THE MARYLAND-NATIONAL CAPITAL PARK AND PLANNING COMMISSION

MEMORANDUM

REVIEW TYPE: Preliminary Plan and Site Plan Review
APPLYING FOR: R-200/MPDU Option; 11.2 Acres;
25 Lots - 19 Single Family Detached Dwelling Units, 6 Single Family
Semi-Detached Dwelling Units

PROJECT NAME: **Bonifant Park**
CASE #: Preliminary Plan No. 1-02037 – Site Plan No. 8-02011
REVIEW BASIS: Request is Being Considered Under the Special Ceiling Allocation for
Affordable Housing Pursuant to the FY 2002 Annual Growth Policy
Requiring Site Plan Review - Article 59-D
Waiver Requested to Eliminate Sidewalks On One Side of the Proposed
Public Street, Subd. Regs. 50-26(h)

PRELIMINARY SUBDIVISION PLAN
LOTS 1-25, Parcels A - E
BONIFANT PARK
P. 3531, P. 3565, P. 3564 & P. 485
13TH ELECTORAL DISTRICT - MONTGOMERY COUNTY - MARYLAND

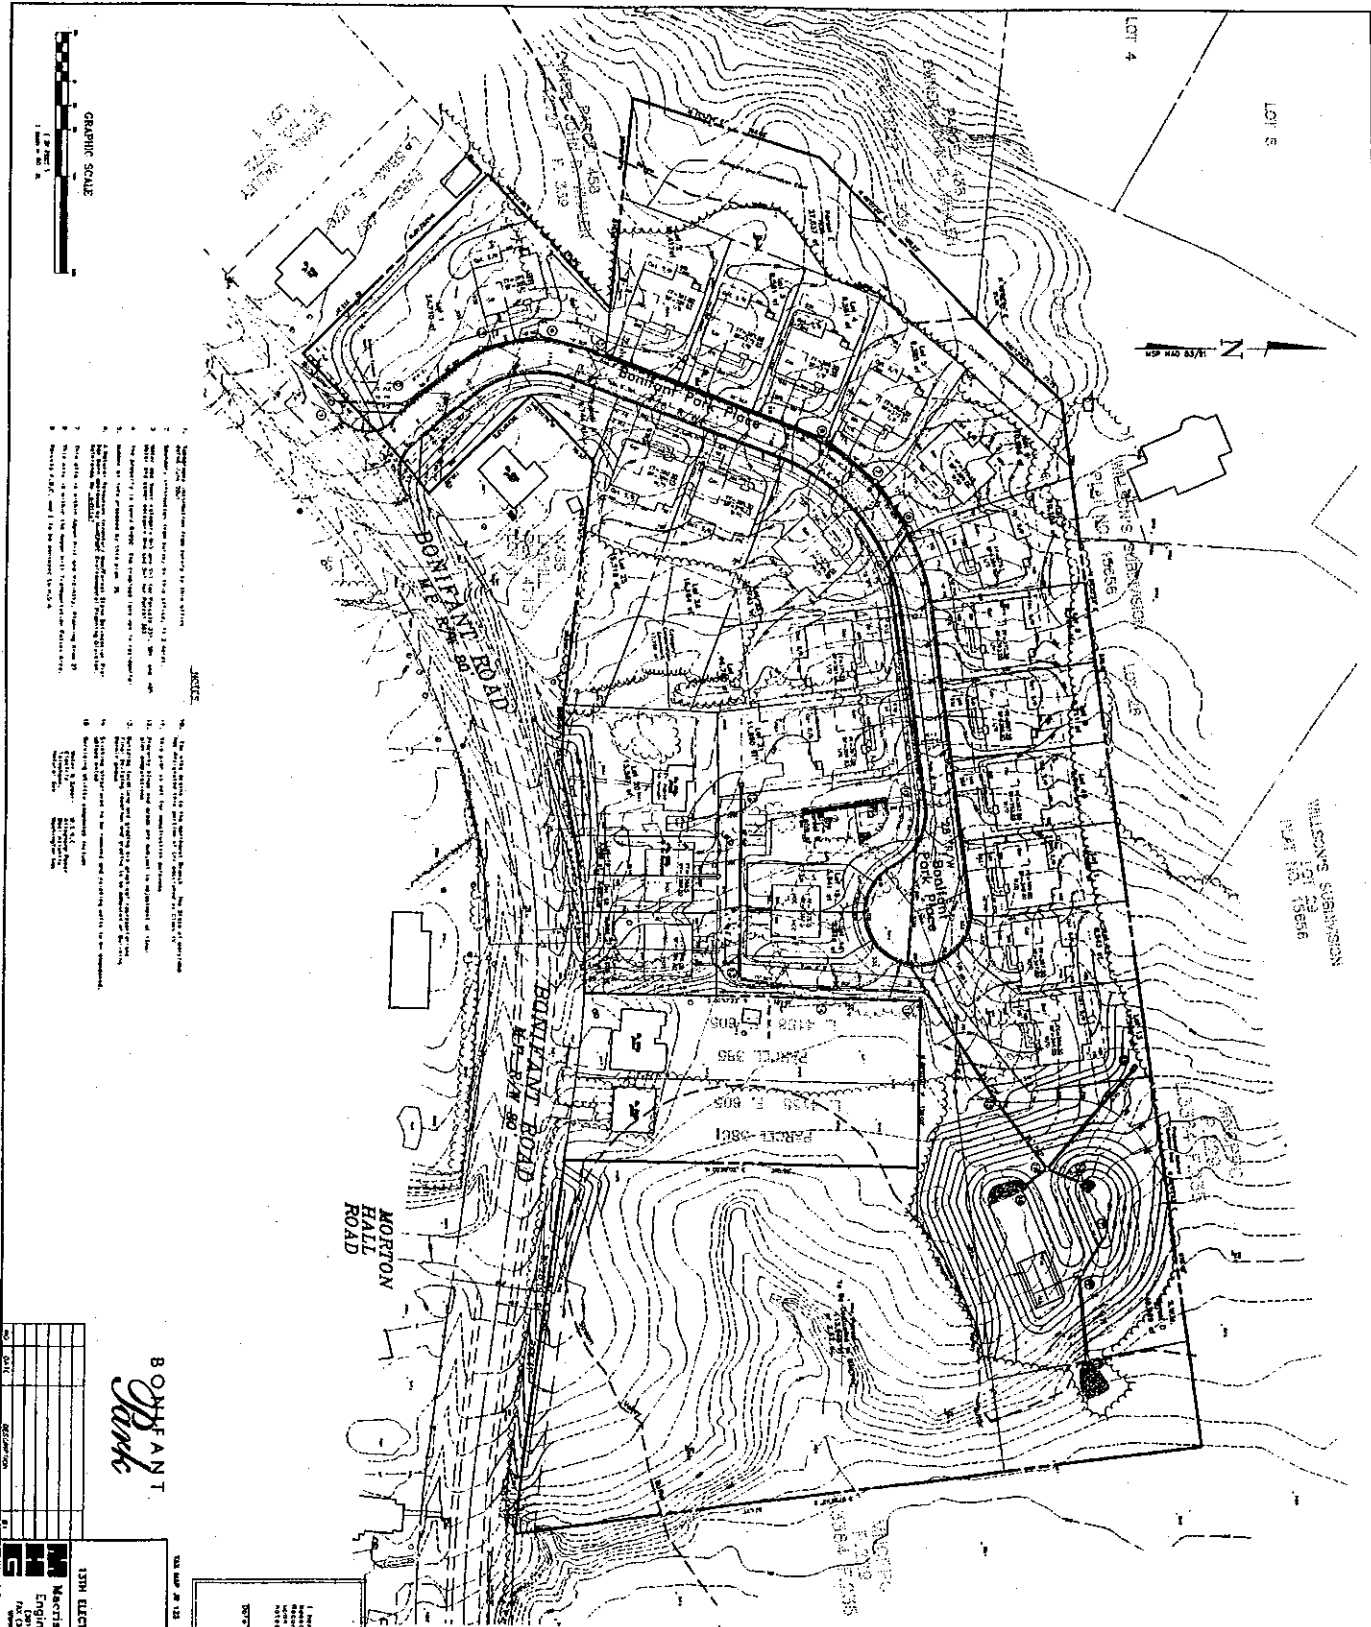
A waiver is required for the site plan to eliminate the sidewalks on one side of the proposed public road. In order to approve the waiver, the Planning Board must find that pedestrian safety can be accommodated with the sidewalk located on one side only of the roadway. Previously, a waiver was approved for an overlength cul-de-sac with the Preliminary Plan #1-01037 [See Condition #11, Preliminary Plan].

Based on the number of units associated with this plan, staff finds that the pedestrian safety can be accommodated with the single sidewalk on the south side of the proposed road. M-NCPPC staff and DPW&T support the waiver request to eliminate the sidewalk

A waiver of sidewalks on the northern side only of the proposed cul-de-sac within the subdivision was reviewed as part of the site plan. Staff and DPW&T support the waiver due to minimal pedestrian traffic within the subdivision and the absence of sidewalks along Bonifant Road.

On behalf of the applicant, Bonifant Park, L.C., we request Planning Board approval for the provision of sidewalk on one side of the proposed tertiary streets in accordance with Section 50-26.(h)(3) of the County Code.

We believe that the one sidewalk will adequately and safely serve the residents of the proposed 25 lots while minimizing impervious area.

First, I am not happy about the density of the proposed development. The subdivision is in an area that is zoned R-200, with an ordinary minimum lot size of 20,000 square feet. Yet four of five lots which adjoin my property (Lots 7-11) are less than 10,000 square feet, or less than half the size ordinarily required, and the fifth lot is just barely more than 10,000 square feet. The houses themselves would extend to within five feet of the sides of the lots, making the houses only 10 feet apart. This is very much out of character with the surrounding neighborhoods, such as on Longmead, Norvale and Gilpin Roads, and Layhill Valley Court, where lot sizes either meet or exceed the ordinary R-200 requirements.

The plans for the proposed new subdivision appear to contemplate something of a buffer between the subdivision and my lot, but at least part of that buffer is inadequate. It appears that the existing mature trees on proposed Lots 10 and 11 would be retained to a depth of about 30 feet from my property. However, that narrows to about 20 feet on proposed Lot 9 and to about 10 feet on proposed Lots 7 and 8. Particularly on proposed Lot 7, it appears that a number of mature trees would be removed that are relatively close to my property line, including some with trunk diameters of close to two feet. I believe that more of the existing mature trees along the property line should be saved. If that is not possible (or if some trees die as a result of the disturbance from the construction despite efforts to save them), then it should be required that substantial evergreen trees be planted in their place to provide a screen between my property and the new development.

- b. Final Landscape and Lighting Plan to show the following:
 - i. Provide additional evergreen landscaping to the rear of lots 6, 7, 8, 9, 10, 11, and 12 to provide additional screening for existing Lots 27 and 28 adjacent to the site

- ii. Provide 5 ft. concrete walk on south side of proposed street
 - iii. Recreational amenities and the proposed asphalt trail through Parcel D to be constructed by the applicant at 70% completion or prior to release of the building permit for the 19th lot
